**DEPARTMENT OF TRANSPORTATION****National Highway Traffic Safety Administration****49 CFR Part 571**

**Federal Motor Vehicle Safety Standards; Electric-Powered Vehicles; Electrolyte Spillage and Electrical Shock Protection**

**ACTION:** Final rule; response to petitions for reconsideration.

Figure 1. S7.6.3 and S7.7 Voltage Measurements of the High Voltage Source

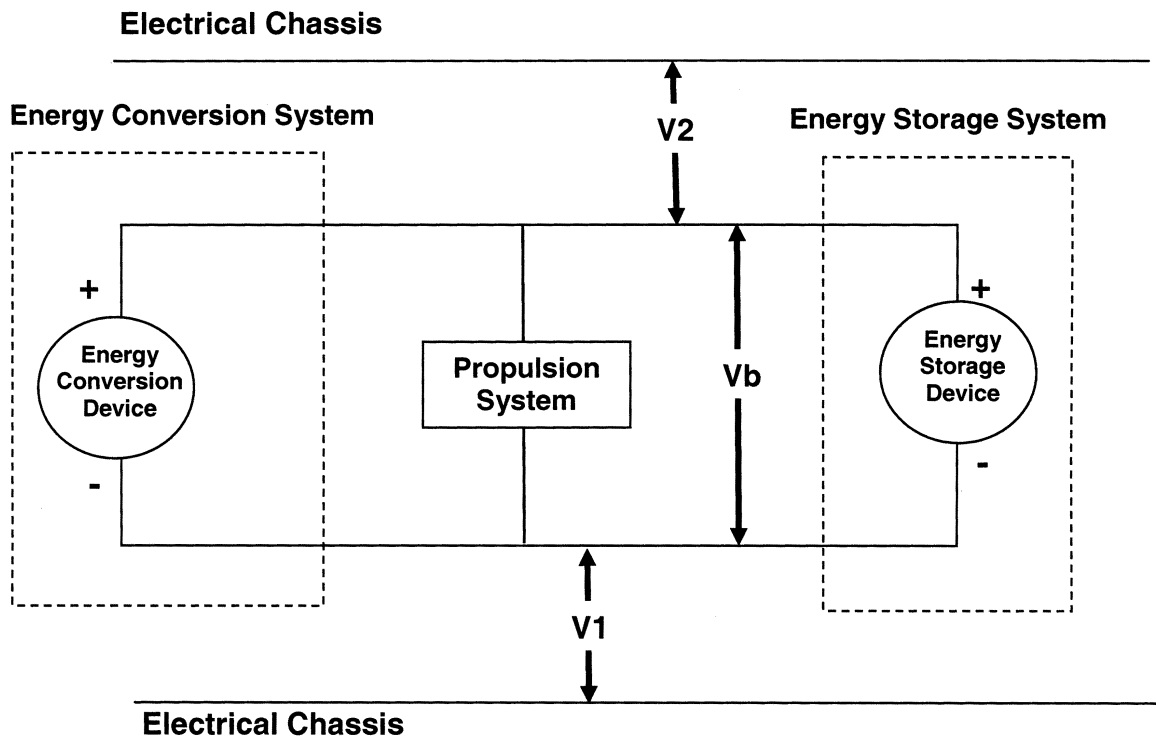
The Alliance also stated in its petition that S5.3(b) of the final rule adopted a low-voltage option for providing electrical isolation, while S7.7 specifies the procedure for measuring the voltage. The Alliance petitioned that, for purposes of clarity, the language currently specified in S7.6.1 regarding voltage measurement locations for the electrical isolation option be added to S7.7 for the low-voltage option.

*NHTSA's Response:* The agency agrees with the Alliance that the procedure to measure the voltage in S7.6.1 should be added to S7.7 for the

purposes of improving clarity. However, we believe S7.6.1 needs to be modified to utilize the new definitions adopted above and to clarify the measurement procedure before its contents are added to S7.7. The test procedures in paragraph S7.6.1 of the June 14, 2010 final rule states:

S7.7 *Voltage measurement.* For the purpose of determining the voltage level of the high voltage source specified in S5.3(b), voltage is measured as shown in Figure 1. Voltage Vb is measured across the two terminals of the voltage source. Voltages V1 and V2 are measured between the source and the electrical chassis. For a high voltage source that has an automatic disconnect that is physically contained within itself, the electrical isolation measurement after the test is made from the side of the automatic disconnect connected to the electric power train or to the rest of the electric power train if the high voltage source is a component contained in the power train. For a high voltage source that has an automatic disconnect that is not physically contained within itself, the electrical isolation measurement after the test is made from both the high voltage source side of the automatic disconnect and from the side of the automatic disconnect connected to the electric power train or to the rest of the electric power train if the high voltage source is a component contained in the power train.

**Figure 2. S7.6.4 Measurement for V1 Voltage between the Negative Side of the High Voltage Source and the Electrical Chassis**

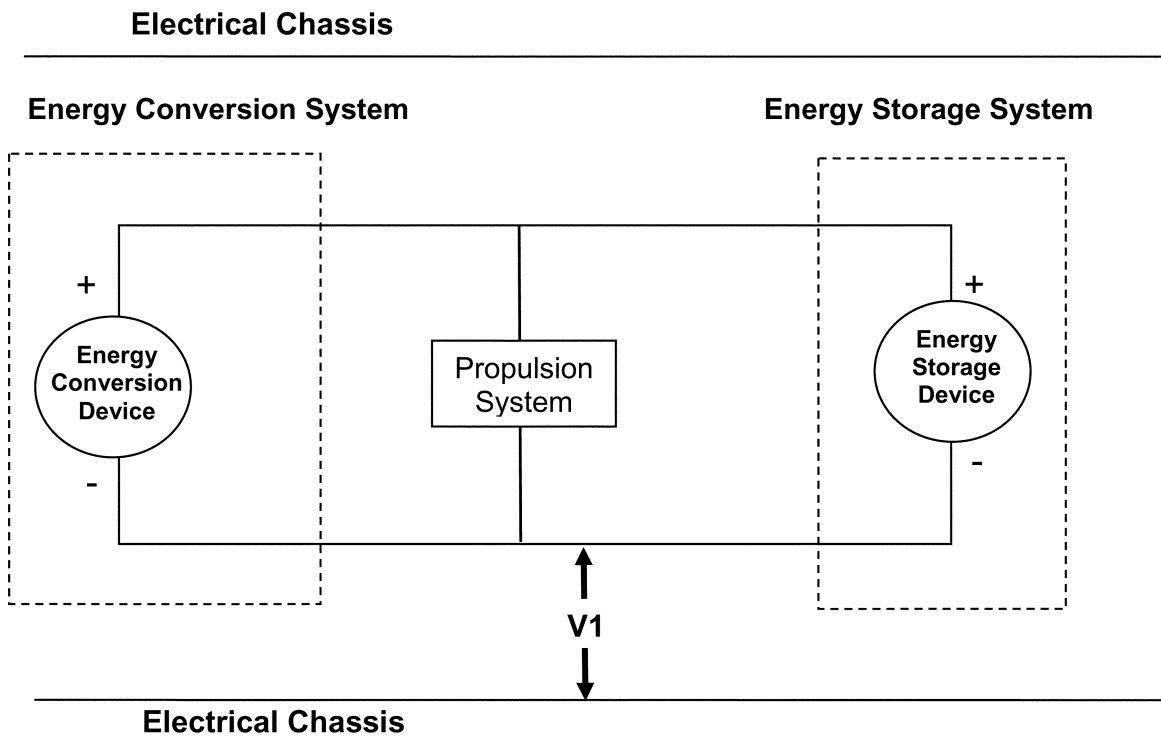
- Specifies the voltage measurement locations for high voltage sources with and without automatic disconnects in the test procedures for determining electrical safety.

S7.6.4 The voltage(s) is/are measured as shown in Figure 2, and the voltage(s) (V1) between the negative side of the high voltage source and the electrical chassis.

**Figure 4. S7.6.6 Measurement for  $V_{1'}$  Voltage across Resistor between Negative Side of the High Voltage Source and Electrical Chassis**

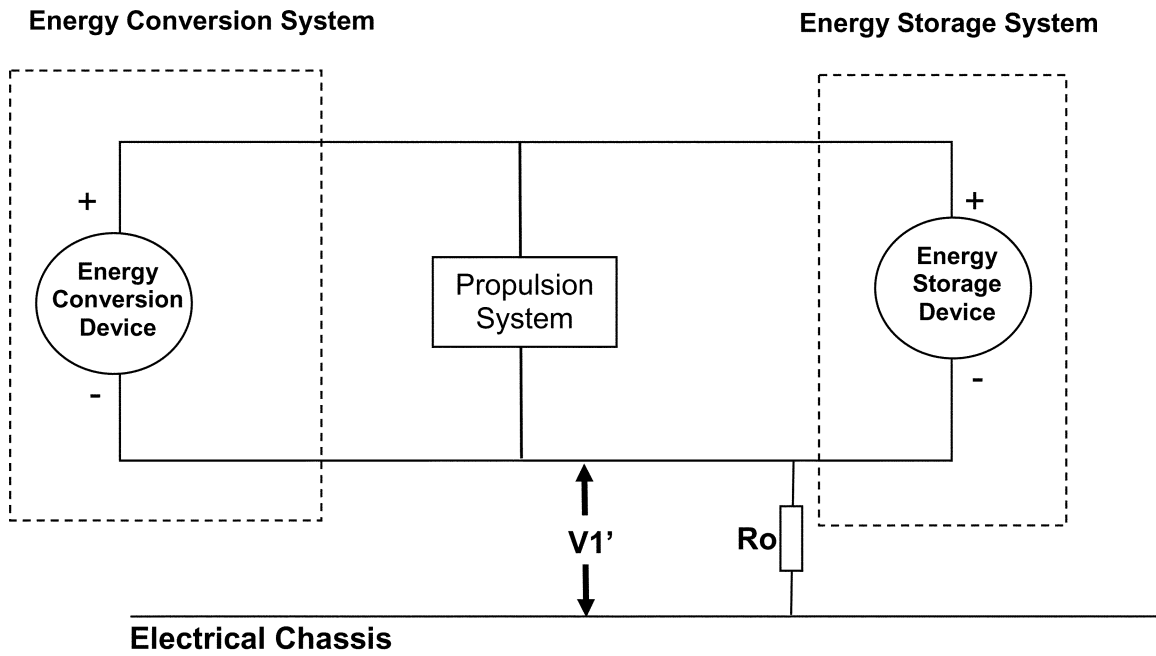
determine if the isolation monitoring system is operating correctly. It argued that allowing a higher resistance would not compromise the stringency of the requirements since it would provide for a worse case condition. In the June 14, 2010 final rule, the resistance of the external resistor applied in the test procedure detailed in S8 is calculated such that the combined electrical isolation resistance of the high voltage source and the external resistor results in electrical isolation of 95 ohms/volt which is 95 percent of the required electrical isolation. The electrical isolation monitor is required to display a warning when the electrical isolation falls to 95 ohms/volt. If the resistance of the external resistor applied in the test is greater than that specified in S8, as requested by Honda, then we agree that the combined electrical isolation for which the monitoring system will need to display a warning may be greater than 100 ohms/volt, thereby making the requirement more stringent.

The final rule requires 100 ohms/volt electrical isolation for monitored DC high voltage sources. For compliance purposes, we are assessing the operation of the monitoring system when the electrical isolation falls just below the required value. The final rule does not preclude manufacturers from having the isolation monitor warning display come on at a higher value than the minimum electrical isolation of 100 ohms/volt. Therefore, we do not believe it is necessary to grant Honda's request to change S8(4) to include an external resistor of higher resistance than that specified by the calculation.

S7.6.6 If V1 is greater than or equal to V2, insert a known resistance (Ro) between the negative side of the high voltage source and the electrical chassis. With the Ro installed, measure the voltage (V1') as shown in Figure 4 between the negative side of the high voltage source and the electrical chassis. Calculate the electrical isolation resistance (Ri) according to the formula shown. Divide Ri (in ohms) by the working voltage of the high voltage source (in volts) to obtain the electrical isolation (in ohms/volt).
